SR 360 WIDENING
CSSTP-0006-00(049) - P.I. No. 0006049
Cobb and Paulding Counties, Georgia

Value Engineering Study Report
Preliminary Design Stage

re: Project No. CSSTP-0006-00(049), P.I. #0006049
Widening of SR 120/Charles Hardy Parkway to SR 176/Lost Mountain Road
Value Engineering Study Report

ALTERNATIVE No.
G-2
SHEET 2 OF 7

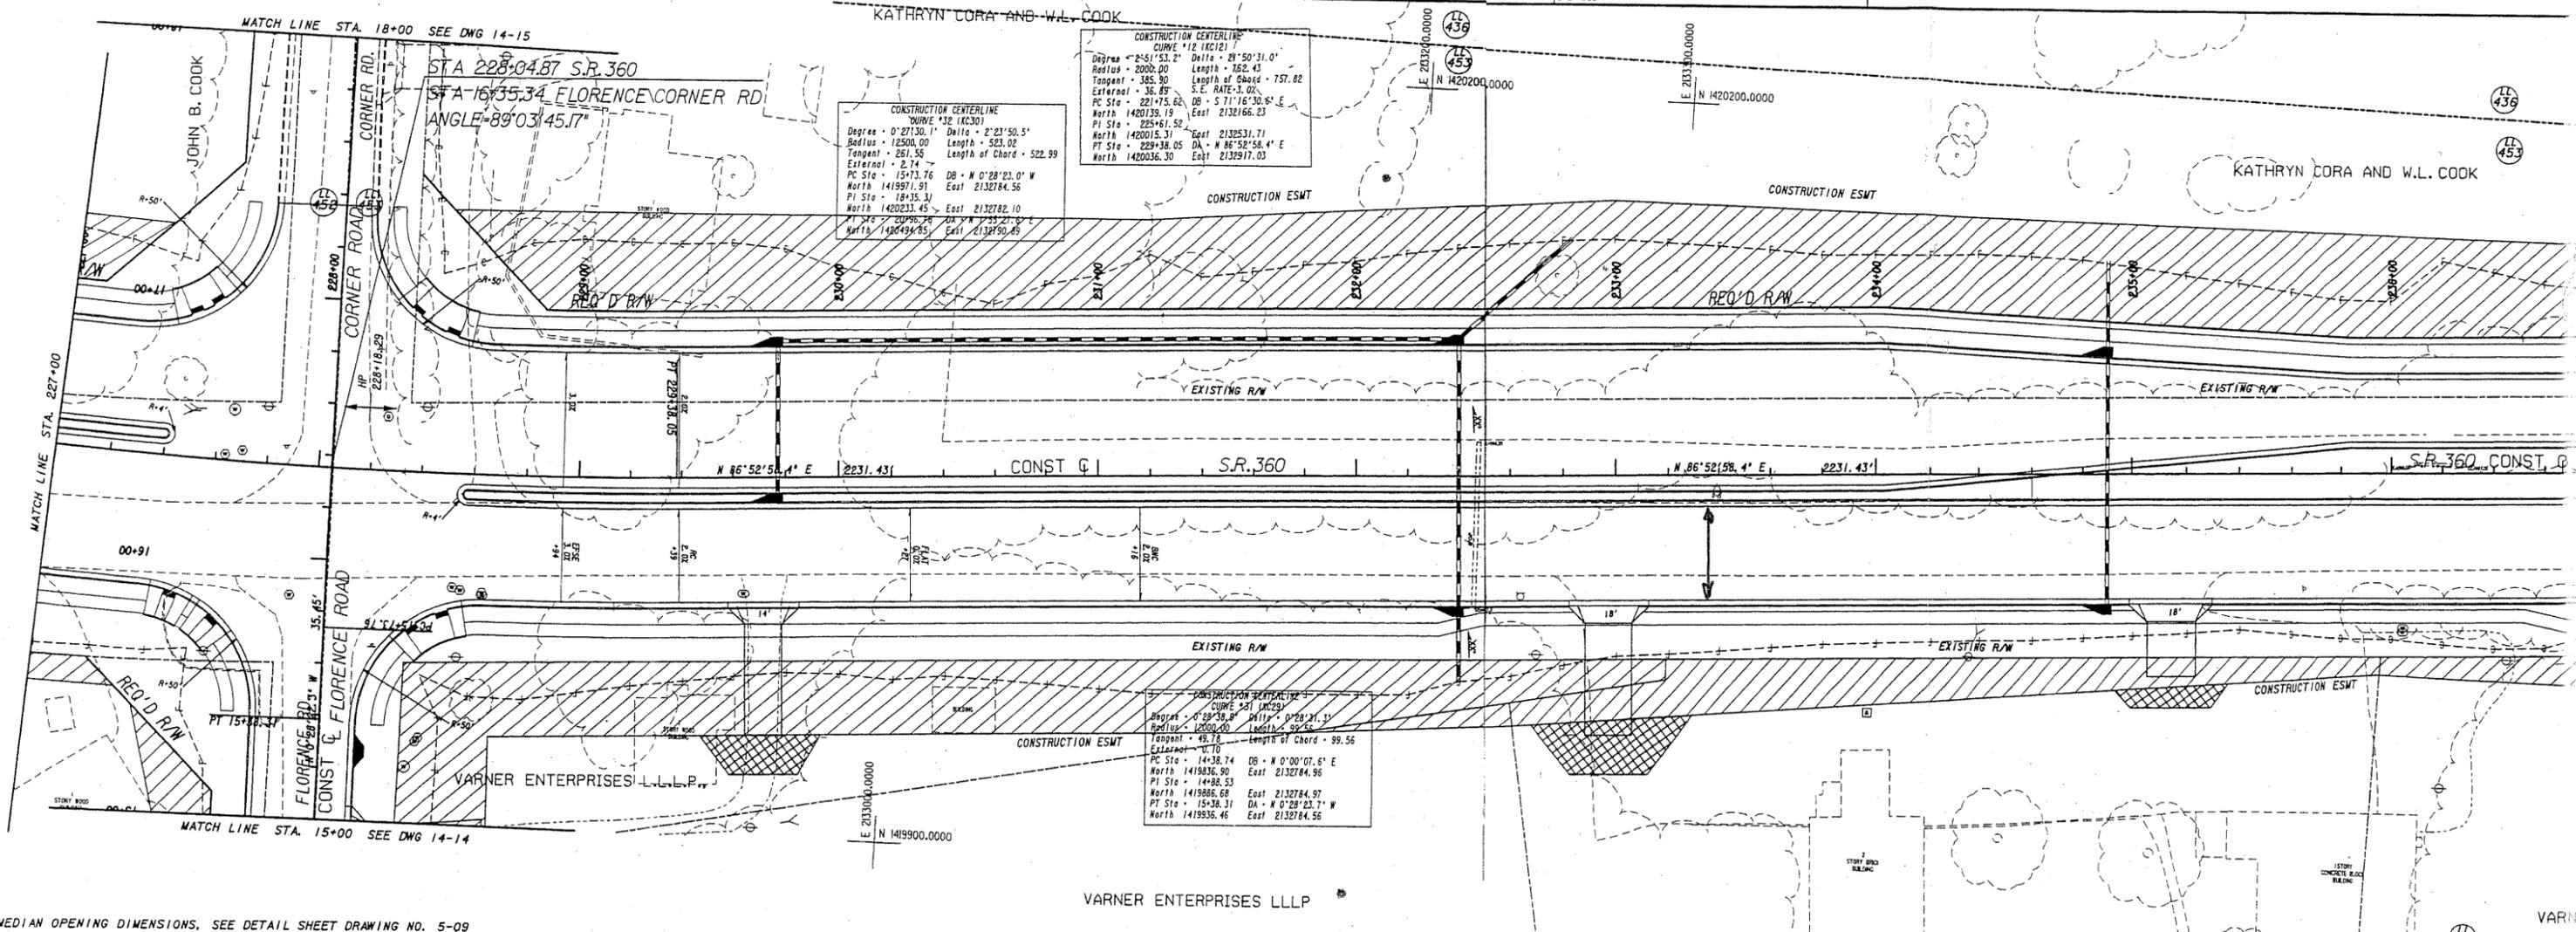
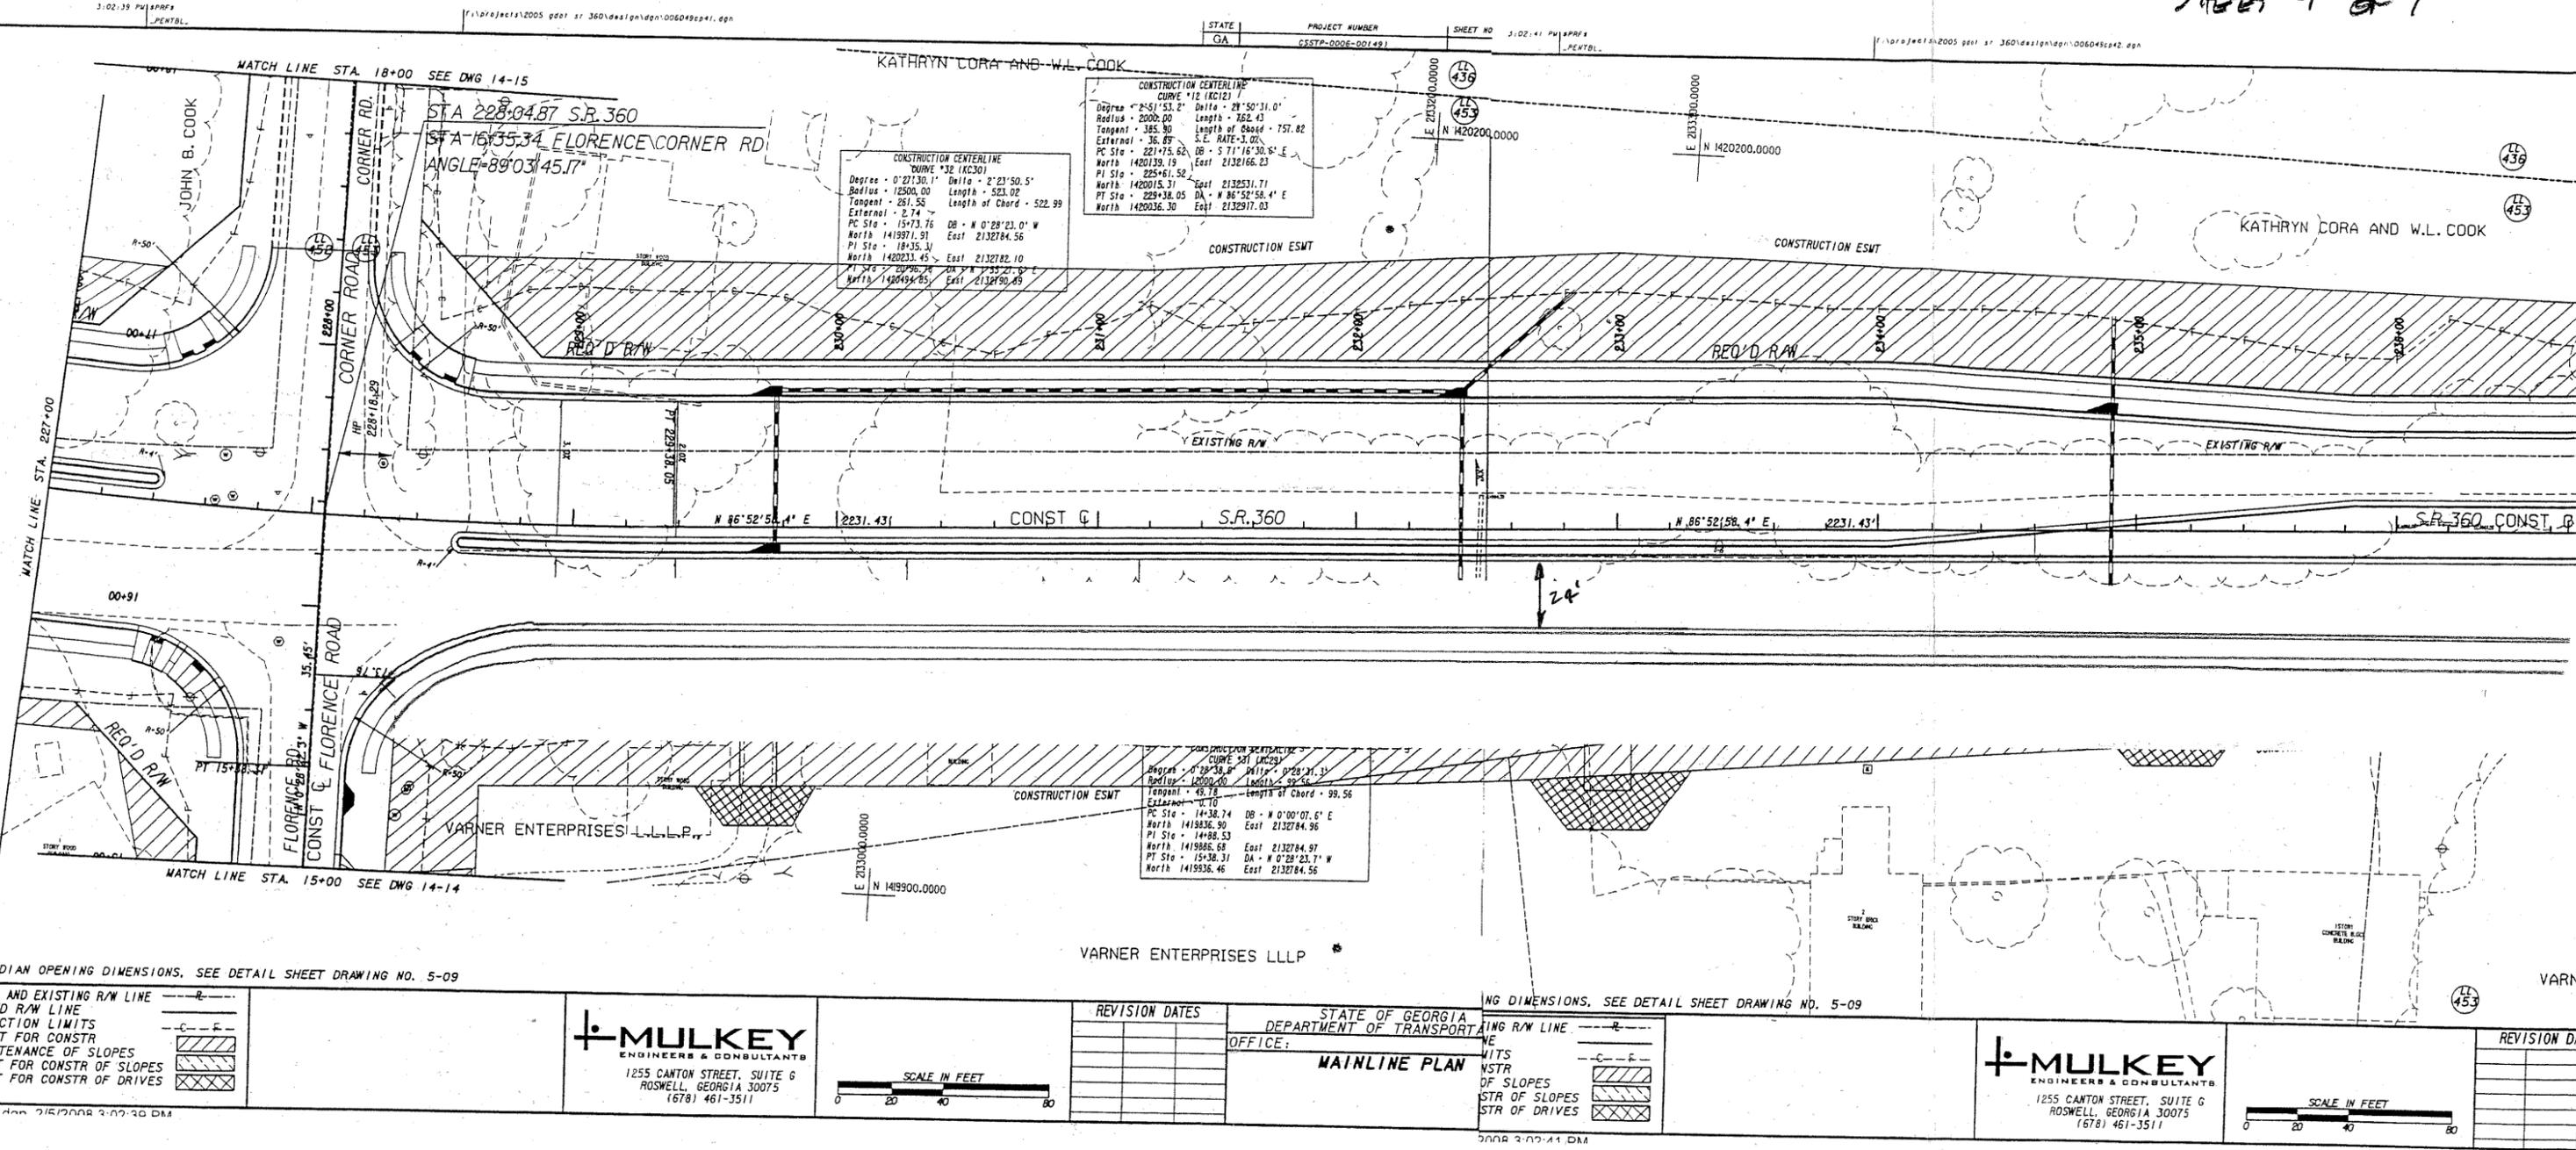
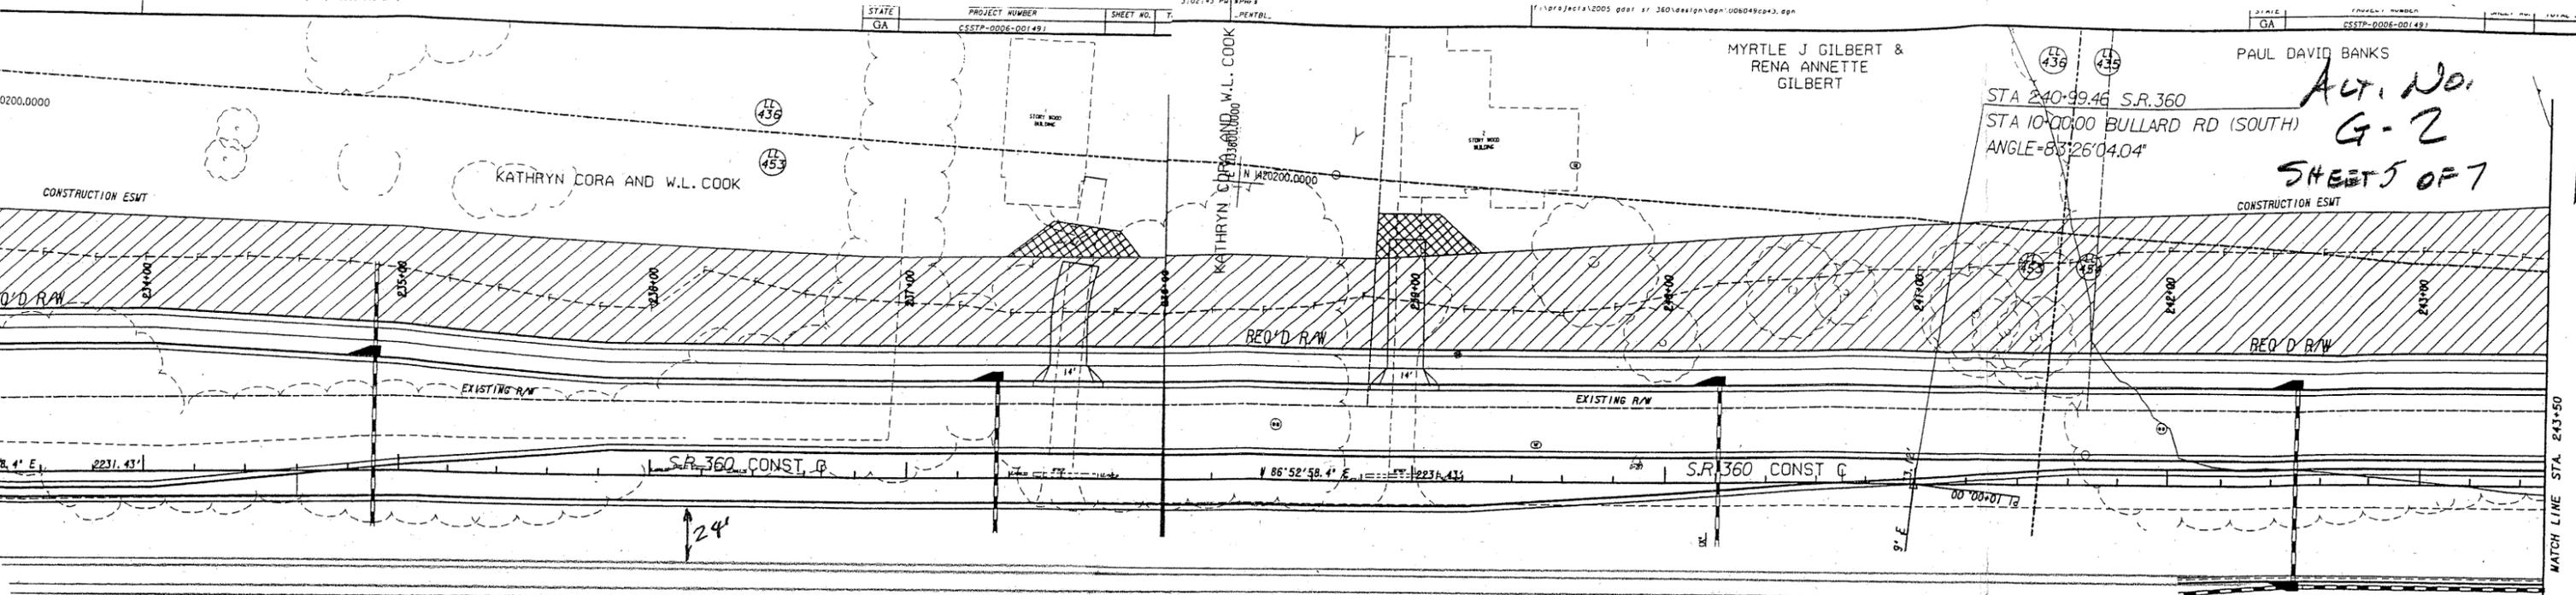
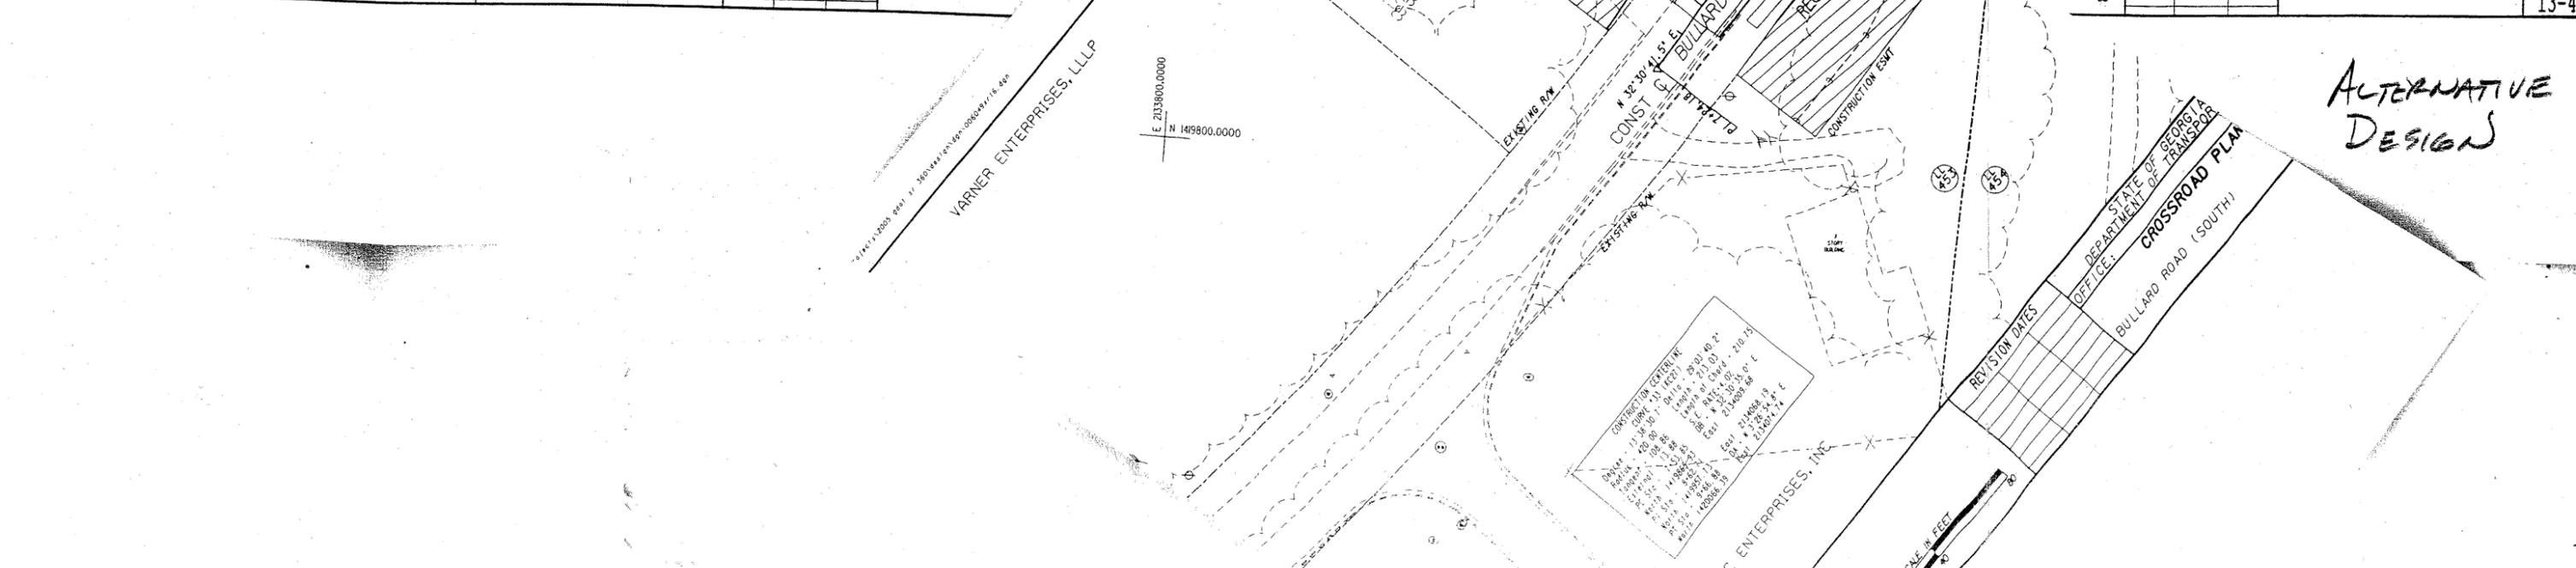
DESCRIPTION: **CUL-DE-SAC BULLARD ROAD ON SOUTH SIDE OF SR 360 (MACLAND ROAD) AND DELETE THE TEE INTERSECTION** SHEET NO.: **1 of 7**

Provide a cul-de-sac on Bullard Road just south of SR 360 and require all traffic to use Florence Road to access SR 360.
